Thermal Circuit Breaker

(Safety Lock-out Switch/Reset/Limited trial for ignition timer for PROTECTOFIER)

Installation Instructions

Style C (Replaces Style A & Style B)

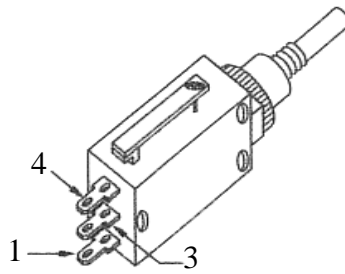
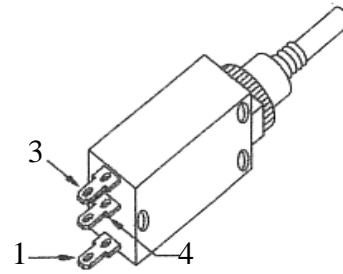
IMPORTANT: Terminals 3 & 4
are in reversed order from Style B.
